# UNITED STATES PATENT AND TRADEMARK OFFICE

APPLICATION NO.	FILING DATE	FIRST NAMED INVENTOR	ATTORNEY DOCKET NO.	CONFIRMATION NO.
10/784,302	02/24/2004	Seiichi Yamamoto	103213-00071	2270

# Office Action Summary

## DETAILED ACTION

**FIG. 4A**

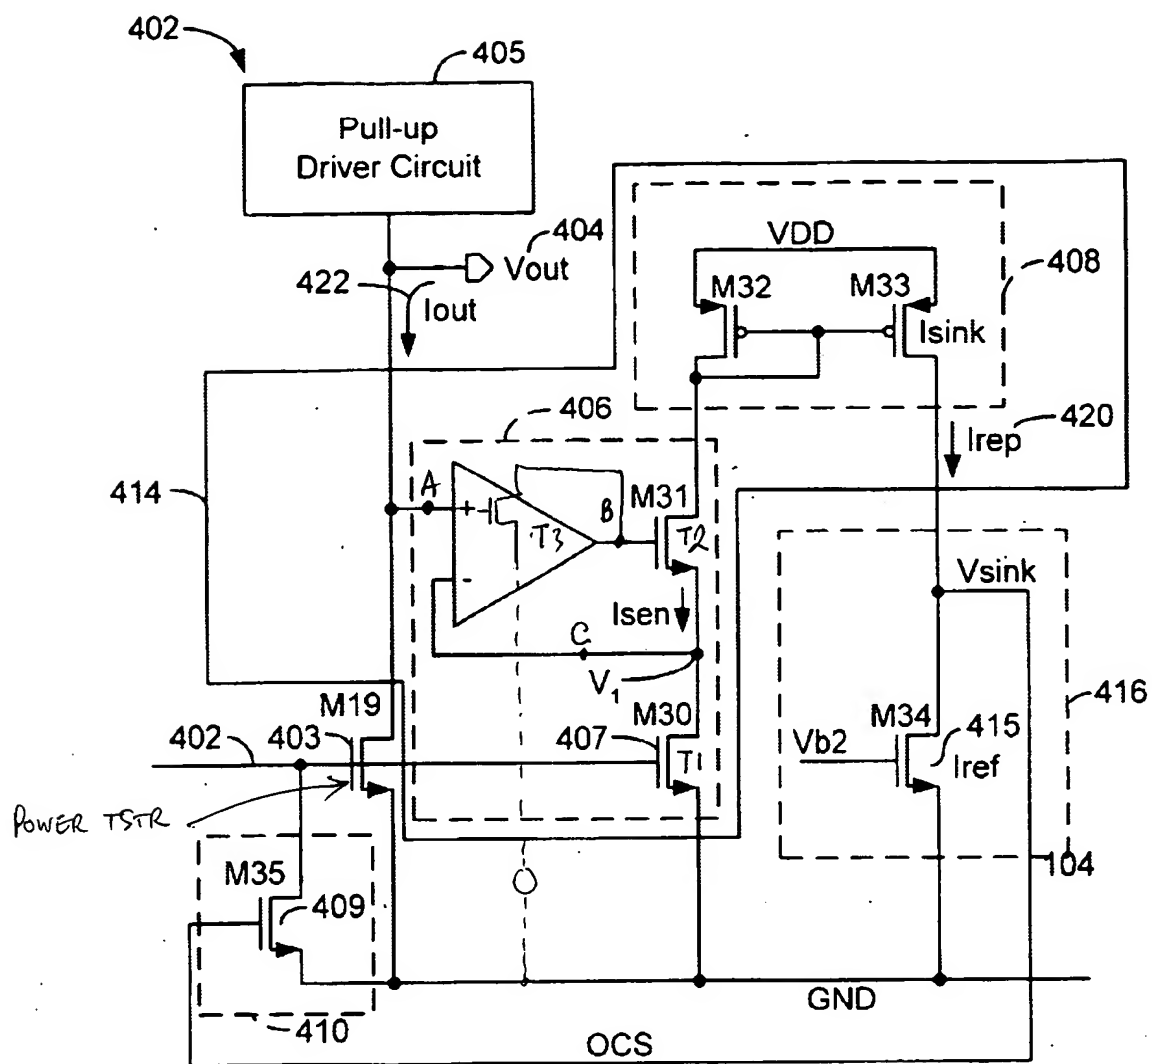
Regarding claim 3, figure 4A of Fotouhi shows a semiconductor integrated circuit comprising:

- a second transistor (M31) of which one of a first electrode or a second electrode is connected to a first electrode of the first transistor (M30). Transistor (M19) draws a very large current ( $I_{out}$ ) which is much larger (100 times) than the sense current ( $I_{sen}$ ) drawn by transistor (M31) (col. 7 lines 1-12). Aota does not show that transistor (M19) is a power transistor. However, it is well known that a circuit having a power transistor can drive a large load. Therefore, it would have been obvious for one having skill in the art to replace transistor (M19) of Fotouhi with a power transistor so that the circuit of figure 4A can drive a heavy load coupled to the output (404).

Figure 4A of Fotouhi includes all the limitations of claim 3, except for the limitation that there is a third transistor coupled to the power transistor (M19) and to the second transistor (M31). It is well known in the art that an op-amp shown in figure 4A basically comprises two input transistors. Figure 4A of Fotouhi does not show the details of the op-amp comprising a third transistor having a gate connected to the first electrode of the power transistor (19) and a second electrode connected to a control electrode of the second transistor (M31). Figures 3 and 4 of Aota shows an op-amp B (M4-M7, M8) comprising a third transistor (M4) having a gate connected receive a first input signal, a second electrode connected to a control electrode of the second transistor (M8) that is equivalent to the second transistor (M31) of Fotouhi. The op-amp of Aota generates an output voltage ( $T_{vref}$ ) that is independent of the temperature coefficient (col. 5, lines 6-14). Therefore, it would have been obvious to one having ordinary skill in the art the replace the op-amp (406) of Fotouhi with the op-amp B of Aota for generating an output voltage that is independent of the temperature coefficient. Note that the combination of Fotouhi and Aota comprises a semiconductor integrated circuit that comprise

a third transistor having a gate connected to the first electrode of the power transistor (M19) and a second electrode connected to a control electrode of the second transistor (M31). See attached drawings.

Regarding claims 4 and 7, the combination of Fotouhi and Aota shows that the first electrode (1) of the third transistor (M4) is connected to the second electrode (2) of the power transistor (M19) and the first transistor (M30). Figure 4 of Aota shows that a direct current voltage (Vcc) is applied to the second electrode of the third transistor (M4) through resistor (load resistor M6).

Regarding claim 5, the combination of Fotouhi and Aota shows that the second transistor (PMOS, M8) and third transistors (NMOS, M4) are transistors of opposite polarities and the second and third transistors are considered to be identical, otherwise stated, and to have the same gate-source voltages.

The second transistor (M8) and the first transistor (M30) are all NMOS transistors.
